PEAKE PLACE SUBDIVISION

The purpose of this application is to create a five-lot subdivision from three existing lots.

DETAIL SITE PLAN

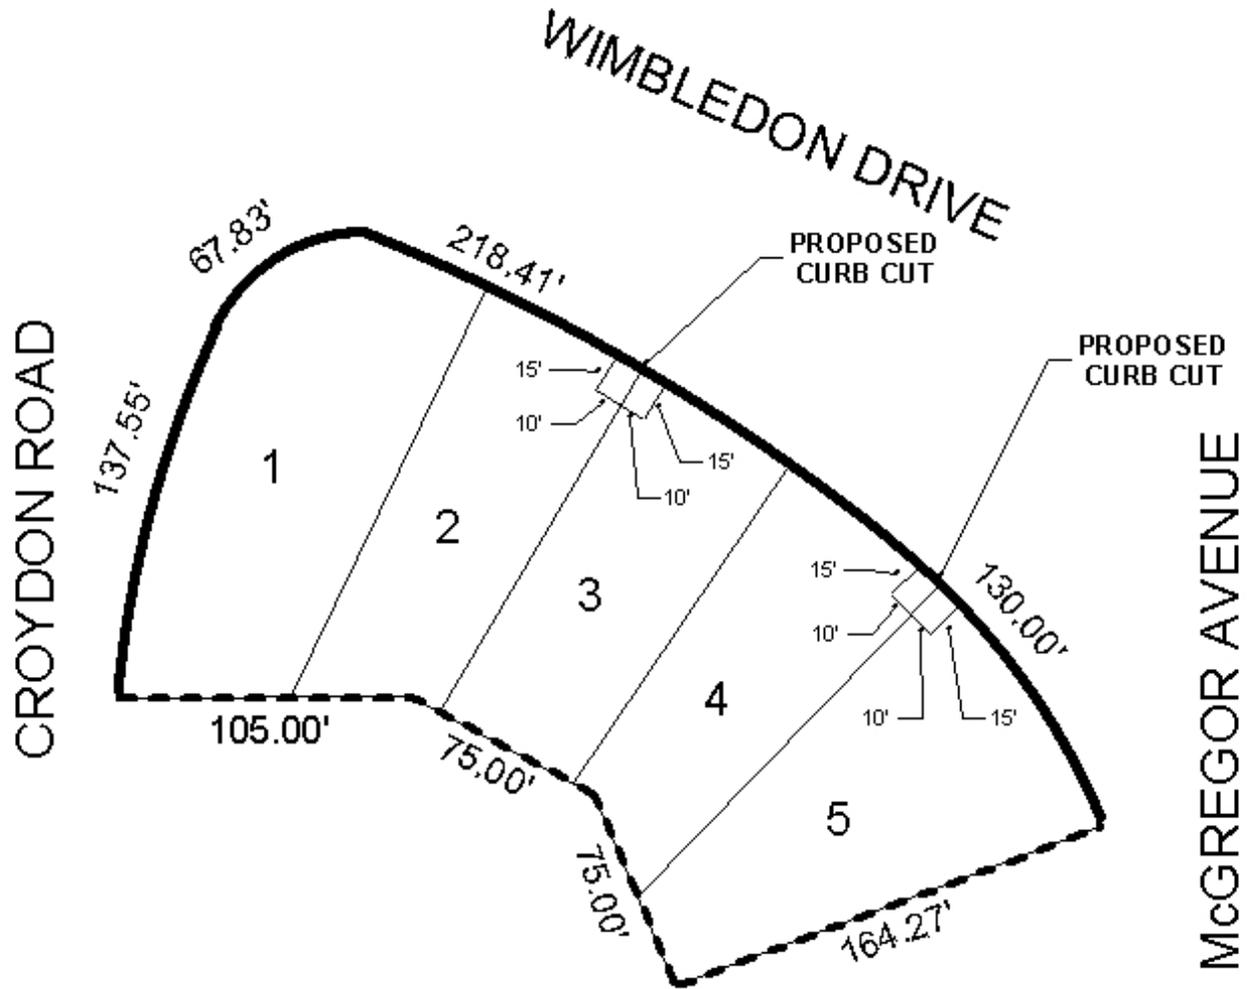
As the proposed subdivision fronts a proposed major street, access management is a concern. The applicant has proposed limiting access for lot 1 to Croydon Road, and limiting the other four lots to two shared access points to Wimbledon Drive East, similar to what was required for the approved subdivision in February 1995. Wimbledon Drive East currently experiences high volumes of traffic during certain periods of the day, and is expected to have increasing traffic volumes into the future. While the subdivision has been designed to limit access to Wimbledon Drive East, future residents of the subdivision will face limited accessibility to and from their property due to traffic volumes; access to their property will frequently be limited to turning right from eastbound Wimbledon Drive East, while exiting will be limited to turning right onto Wimbledon Drive East, and continuing right onto southbound McGregor Avenue. Because of the access issues, consideration of a private access easement and alley for use by the residents of the subdivision, in addition to the proposed restricted access to Wimbledon Drive East, may be appropriate. Due to the proximity to a proposed major street, driveway sizes, location and design must be approved by Traffic Engineering and conform to AASHTO standards.

The 25-foot minimum building setback line, required in Section V.D.9., is not shown for the subdivision, but would be required on the Final Plat.

The plat is recommended for Tentative Approval subject to the following conditions: 1) depiction of the 25-foot minimum building setback line on the Final Plat; and 2) placement of a note on the Final Plat stating that lot 1 is restricted to access only to Croydon Road, and that lots 2-5 share a maximum of two access points to Wimbledon Drive East, with curb cut sizes, location and design to be approved by Traffic Engineering, and conform to AASHTO standards.
